allen price & scarratts pty ltd
land and development consultants

Our Ref: N25489
Your ref: SSD7169

RE: Mundamia Residential Subdivision - Response to the draft Conditions of Consent proposed by DPIE

Please find attached our submission in response to the draft Conditions of Consent which have been proposed by the Department of Planning, Industry and Environment (DPIE).

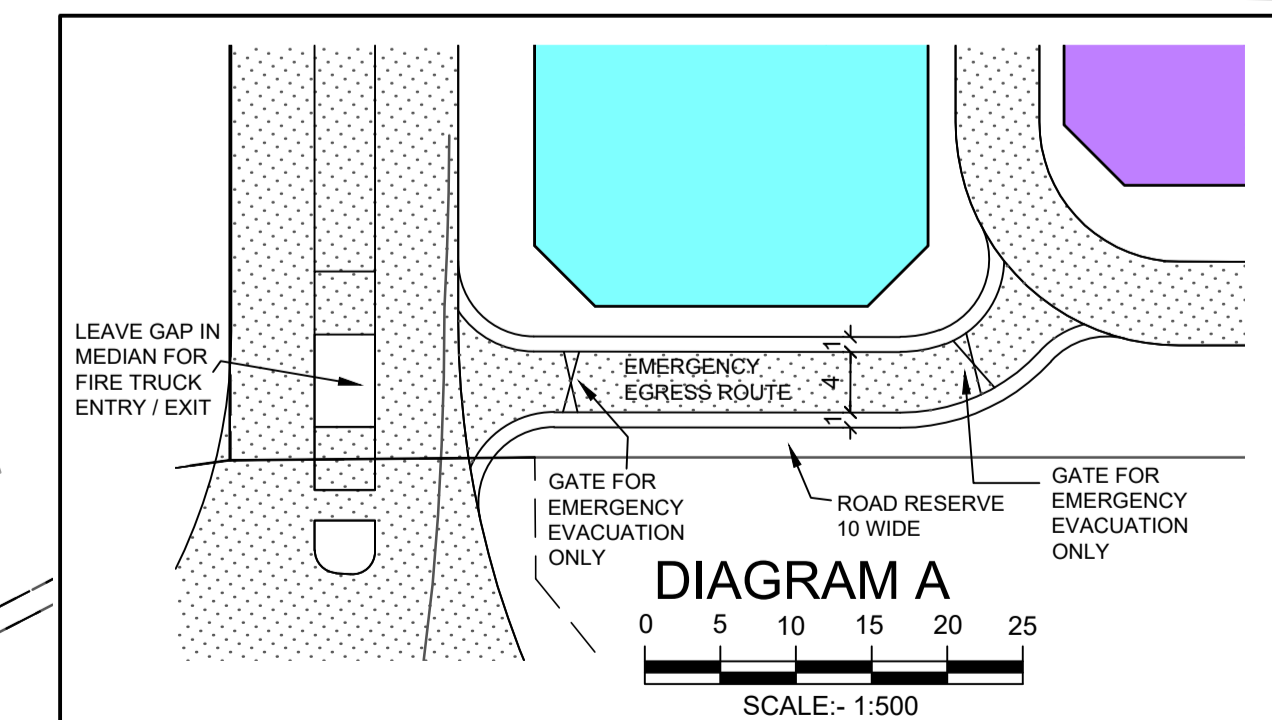
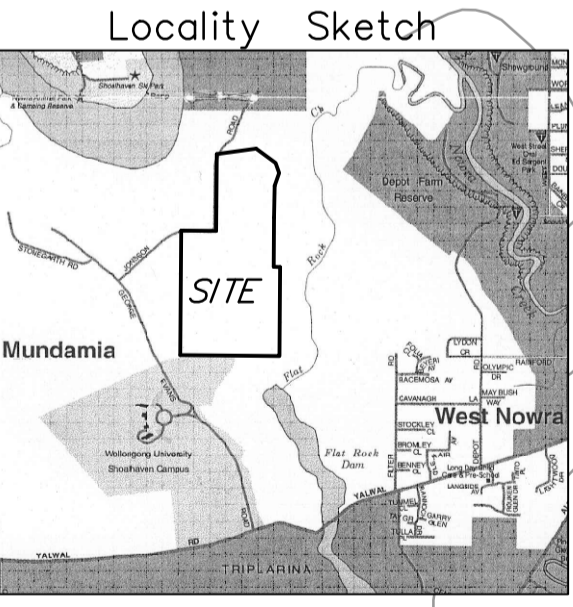
A number of these conditions have been incorporated into APS plan ref 25489-11 Rev 20 (see Appendix A). Further, a number of these conditions are unnecessarily conservative, are in addition to the RFS accepted proposal, exceed the accepted standards and have no scientific or legislative justification.

APS plan 25489-11 Rev 20 responds to the draft conditions of consent as follows:

Condition	Satisfied or Rejected?	Rationale and Justification
A1(8)(a)	Satisfied by the attached plan	The plan shows all lots having minimum lot sizes that comply with the requirements of Shoalhaven LEP2014;
A1(8)(b)	Satisfied by the attached plan	The plan shows all drainage reserves and associated structures and landscape treatments required to facilitate the implementation for the recharge and stormwater management system approved under Condition C5;
A1(8)(c)	Satisfied by the attached plan	The plan ensures a minimum open space of 6,438m ² of open space in areas that exceed 3,000m ² in each reserve;
A1(8)(d)	This condition is rejected	The plan does not provide for the commercial lot. The need for a perimeter road as per Condition A1(9)(b)(i) prevents the commercial lot from being created due to the realignment of the perimeter road. The commercial lot came about during the assessment process when DPIE requested that the subdivision layout be dovetailed into the adjoining Part 3A (MP09_0056) proposed by Council to the west. Whilst the adjoining Part 3A was withdrawn the layout on the subject land was not modified. The creation of the perimeter road and loss of the commercial lot is an improved outcome on the site and is supported;

A1(8)(e)	Satisfied by the attached plan	The plan identifies that a landscape treatment is required along the eastern boundary of the site to prevent vegetation creep with an appropriate note. The detail for this management measure will be outlined as per the proposed modification to Condition C35 as outlined below;
A1(8)(f)	Satisfied by the attached plan	The plan identifies the location of all roundabouts proposed for construction under the Planning Agreement required under Condition C3;
A1(8)(g)	Satisfied by the attached plan	The plan identifies the access road upgrades on or around the site identified in the conditions of consent and the Shoalhaven Contributions Plan 2019;
A1(8)(h)	Satisfied by the attached plan	The plan identifies the SPS is included in Stage 1, along with all necessary public access or initial easements for access and services;
A1(9)(a)(i)	This condition is rejected	The plan does not identify all APZ's as per Table A2.4 of Planning for Bushfire Protection 2006 (PBP2006), nor is it required to. Instead it identifies APZ's which satisfy the "Performance Criteria" of PBP2006 and are based upon more accurate site assessment data inputs as outlined in the email from Rod Rose to RFS dated 27/6/16 (see Appendix B). The proposed performance solution has been accepted by RFS as outlined in its letter dated 4/11/16 (see Appendix C). Further justification to the proposed solution is provided below.

A1(9)(a)(ii)	This condition is rejected	The plan does not identify a 100m wide temporary APZ adjacent to the western boundary of the subject land as outlined in this condition, nor is it required to. The plan provides APZ's along the western boundary of the subject land that are compliant with the Acceptable Solutions in PBP (as per Table A2.4) and as seen on the site inspection it is conservative in applying APZ based upon forest vegetation when the adjoining vegetation is stunted because of shallow soils and past disturbances. An additional temporary APZ on top of an already compliant APZ is unnecessarily conservative, excessively restrictive and has no scientific or logical justification. As the development also benefits from the Neighbourhood

Safer Place (NSP), these conditions are even more out of step with the accepted standards. Further justification is provided below.
A1(9)(a)(iii)	Satisfied by the attached plan	The plan identifies that all proposed APZ's are located outside the E2 zone land.
A1(9)(b)(i)	Satisfied by the attached plan	The plan shows an extension of Road 6 to Road 1 along the western boundary of the site. This road realignment has forced the deletion of the 163m ² "commercial lot" which is an improved outcome for the development.
A1(9)(b)(ii)	Satisfied by the attached plan	The plan shows an extension of Road 7 to Road 1 which is proposed to be closed to general access by RFS compliant gates which can be opened to aid in evacuation from the site in the event of an emergency.
A1(9)(b)(iii)	Satisfied by the attached plan	The plan shows the central median on Road 1 being setback from the intersection of Road 1 and Road 7 to allow easier ingress/egress for emergency vehicles;

A1(9)(b)(iv)	Satisfied by the attached plan	The plan shows all internal roads having widths complying with Section 4.1.3(1) of PBP2006. It should be noted the road widths already comply with PBP2006 and RFS requirements. Further, these requirements are repeated in Condition C16(e) and do not need to be included as a deferred commencement condition as well.
A1(9)(b)(v)	This condition is rejected	The plan does not show parking restrictions as outlined in the draft condition nor is it required to. The road widths already comply with PBP2006. These are unnecessary and are above and beyond the acceptable solutions within PBP2006. Further justification to the proposed solution is provided below.
A1(9)(b)(vi)	Satisfied by the attached plan	The plan contains a note which requires all roundabouts to be mountable to assist with emergency evacuation and emergency vehicle access;
A1(9)(c)	Satisfied by the attached plan	The plan already shows the proposed location of the NSP. Whilst some of the detail of the NSP including exact size, parking requirements, etc, is to be further detailed in consultation with RFS and SCC in order to satisfy Condition A1(1), it is unnecessary to repeat this requirement here;

A1(9)(d)	This condition is rejected	The plan has not been amended to show all perimeter lots having rear laneway access as these are unnecessary to comply with Planning for Bushfire Protection 2006. This condition is excessively conservative, is not founded on bushfire science and will lead to an extremely poor urban design outcome. Further justification is provided below.
A1(9)(e)	This condition is rejected	The plan has not been amended to show all medium density lots a minimum of 100m from a bushfire hazard as these building comply with Planning for Bushfire Protection 2006 and there is negligible benefit in such a proposal. All future development on bushfire prone land will need to comply with the required BAL ratings at that time. Medium density development cannot be undertaken unless the site meets BAL29 requirements which is the case for all lots in a modern subdivision. Further justification is provided below.
